# ADDENDUM 1

PROJECT NAME: **MARTIN LUTHER KING PARK**

DATE: 09/21/2016

PROJECT NO.: **40-00374**

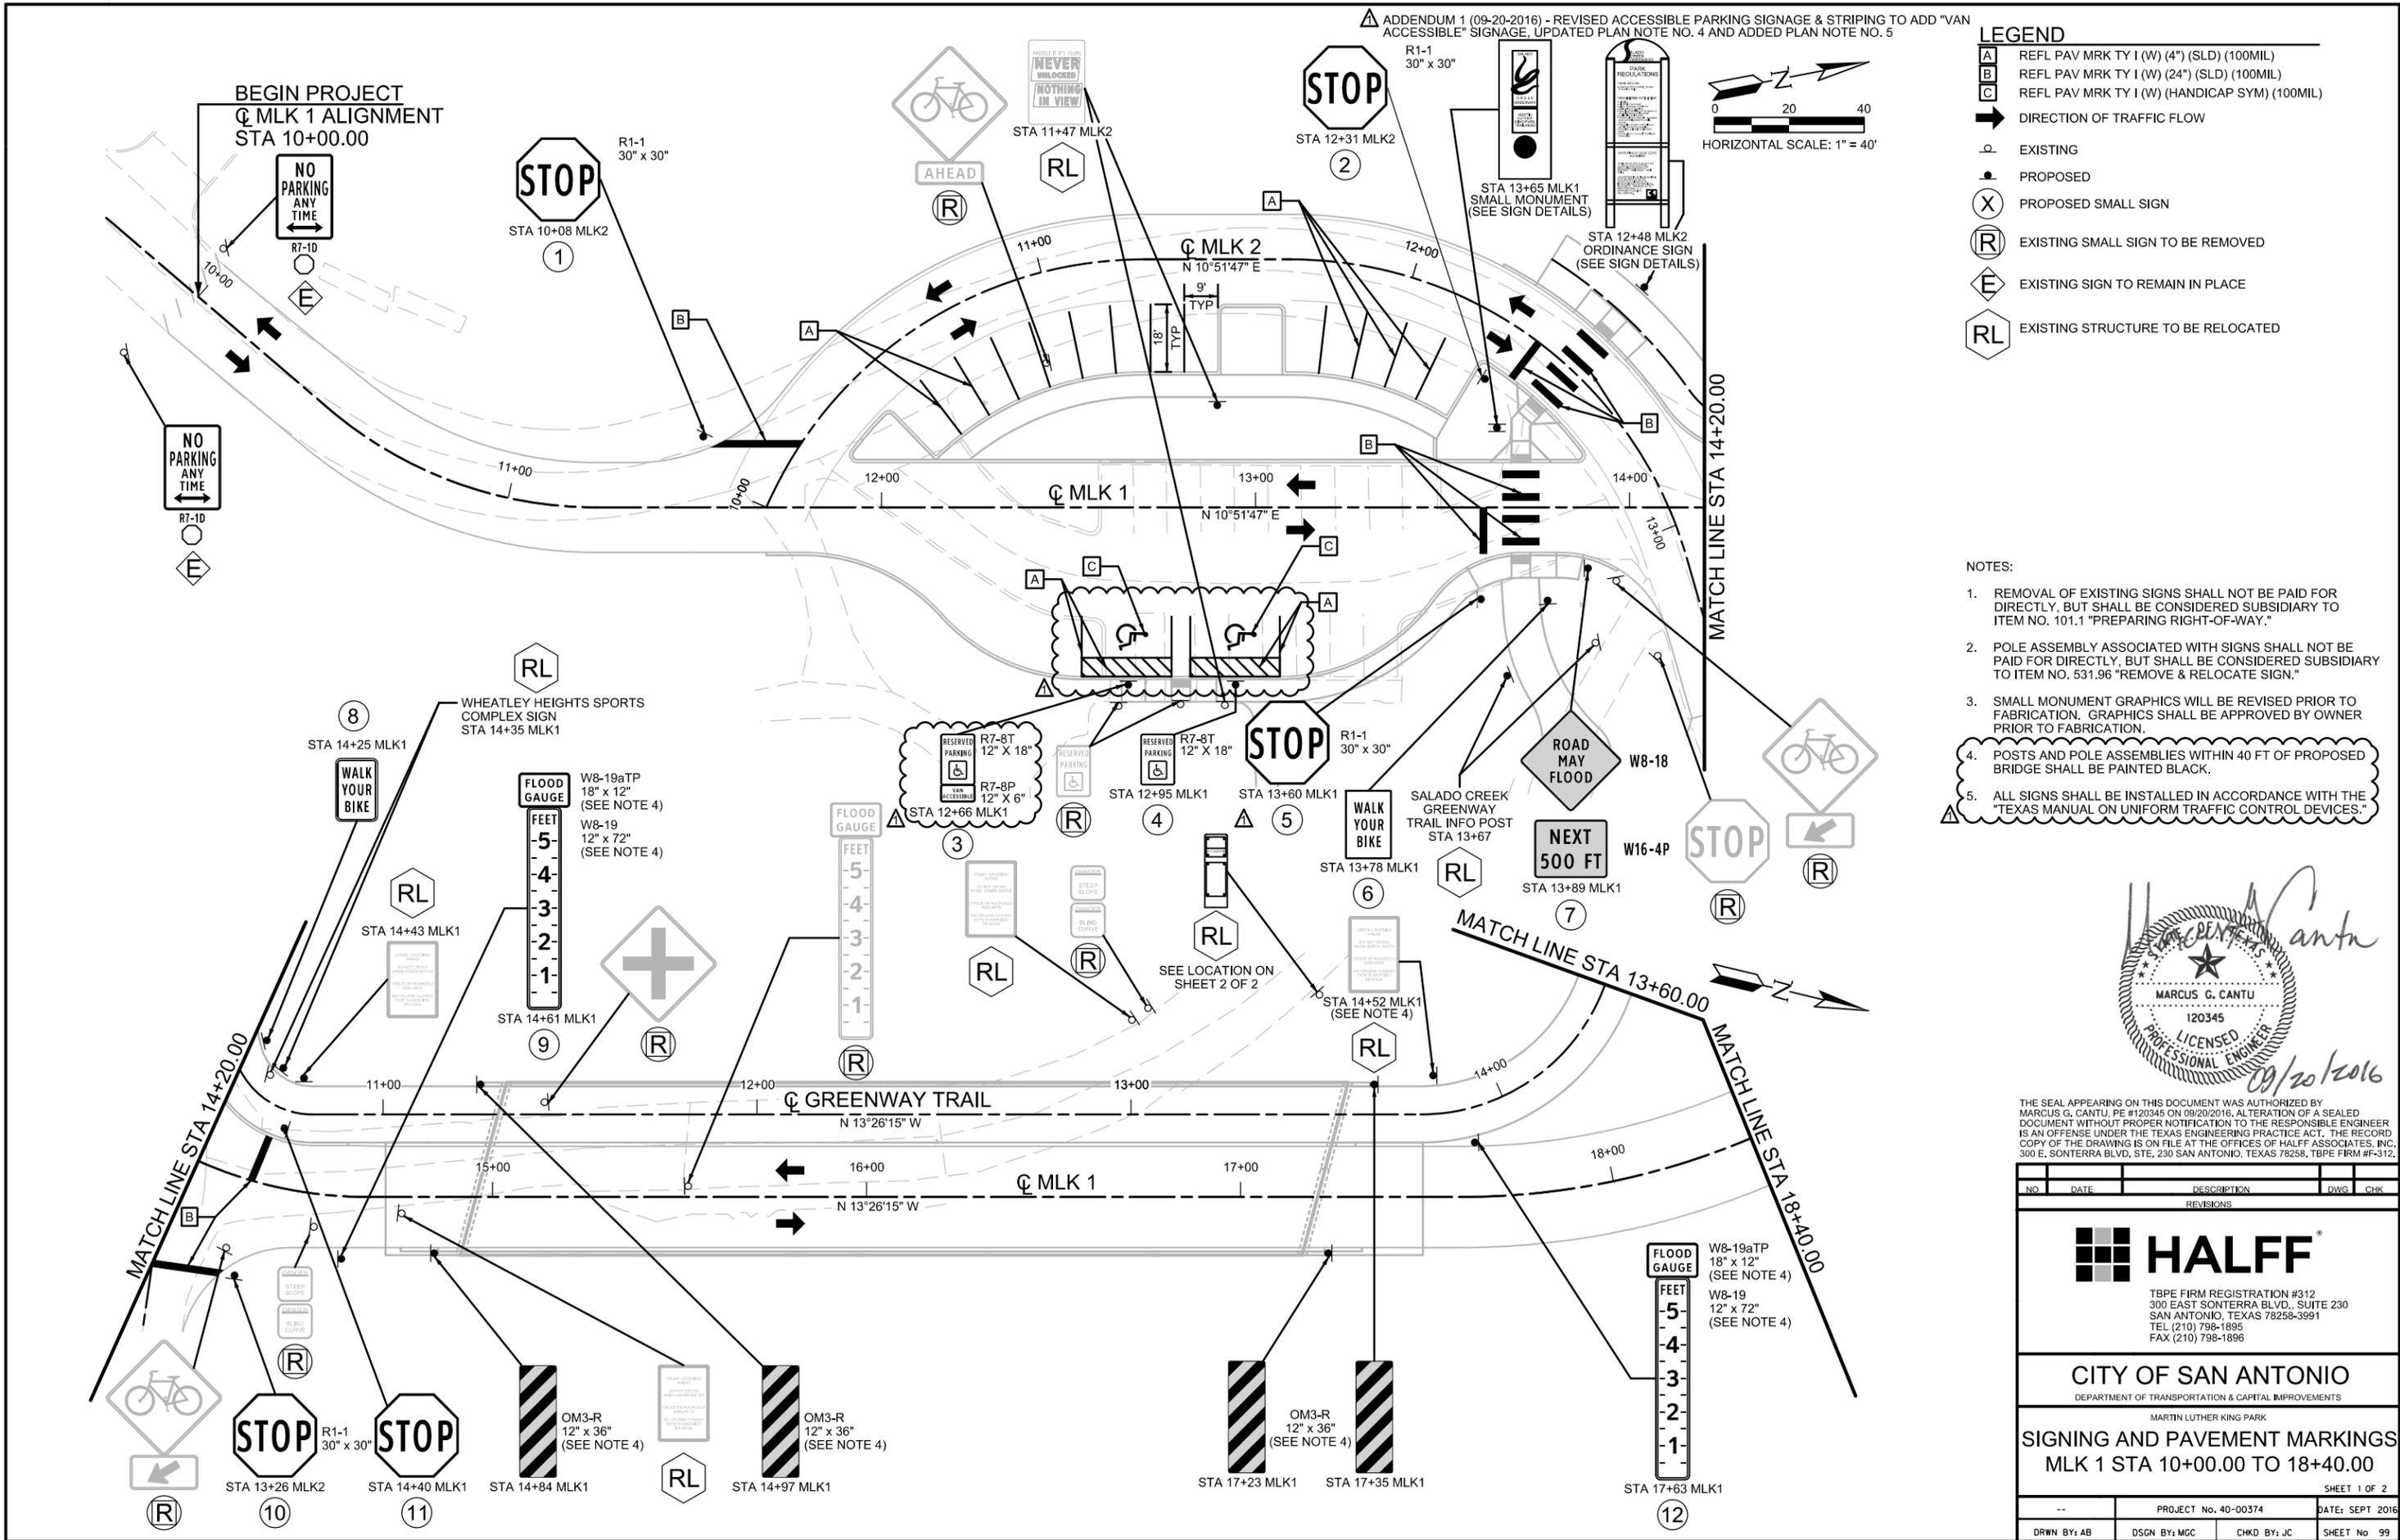
- v. Sheet 99 “SIGNING AND PAVEMENT MARKINGS MLK 1 STA 10+00.00 TO 18+40.00”
    - i. Revised accessible parking spaces configuration
    - ii. Revised accessible parking signage to add “Van Accessible” signage

- iii. Updated plan note No. 4
    - iv. Added plan note No. 5
  - w. Sheet 100 “SIGNING AND PAVEMENT MARKINGS MLK 1 STA 18+40.00 TO 23+66.27”
    - i. Updated plan note No. 4

ADDENDUM 1 (09-20-2016) - REVISED ACCESSIBLE PARKING SIGNAGE & STRIPING TO ADD "VAN ACCESSIBLE" SIGNAGE. UPDATED PLAN NOTE NO. 4 AND ADDED PLAN NOTE NO. 5

DATE: 7/21/16	PROJECT No. 40-00374	SHEET No 107
DRAWN BY: JS	DESIGNER: PCD	CHKD BY: PCD
		SHEET: 6 of 11

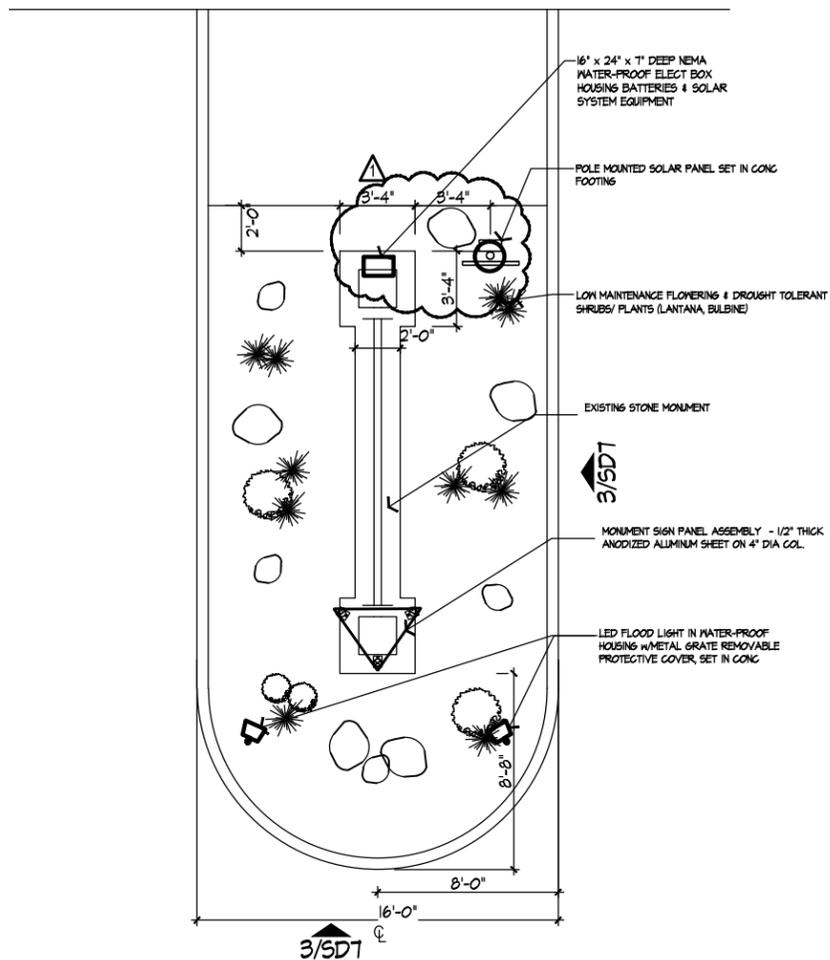
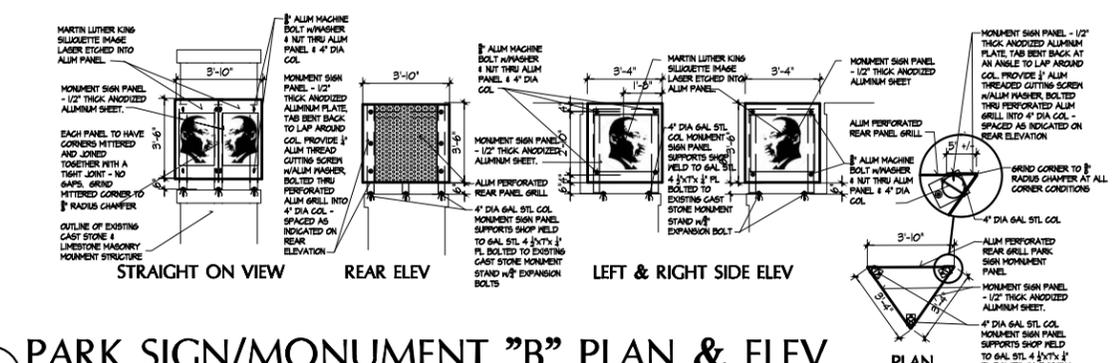
- ii. Added plan note No. 5
  - x. Sheet 107 “MLK PARK – MONUMENT “B””
    - i. Relocated solar panel and pole with battery
  - y. Sheet 110 “MLK PARK – MONUMENT “B” ELECT LTG & SOLAR PWR”

CONTRACTOR RESPONSIBLE FOR FACILITATING AND APPLYING FOR SAN ANTONIO SIGN PERMITS  
 SOLAR PANEL AND POLE WITH BATTERY RELOCATED 09/15/2016

DATE: 7/21/16	PROJECT No. 40-00374	SHEET No 110
DRAWN BY: JS	DESIGNER: PCD	CHKD BY: PCD
		SHEET: 9 of 11

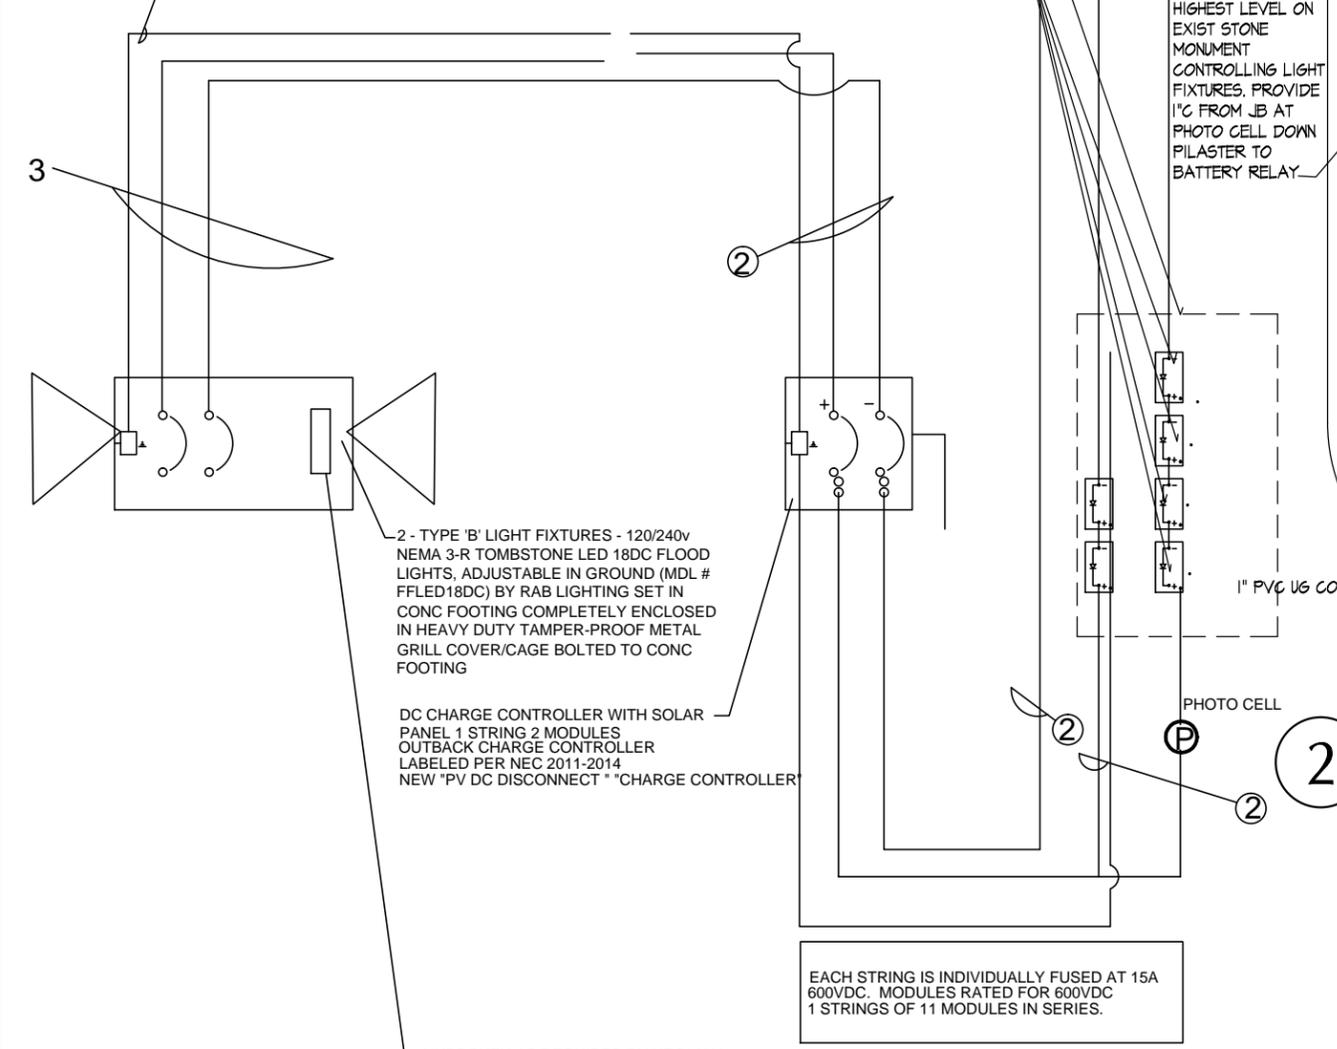
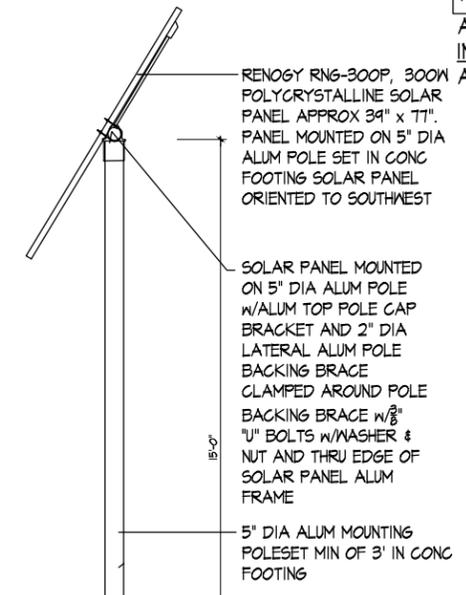
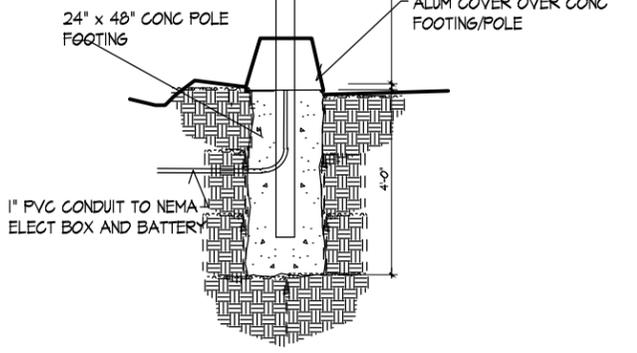
- i. Relocated solar panel and pole with battery
2. Substitute and utilize the revised “List of Governing Specifications, Special Provisions and Special Specifications”
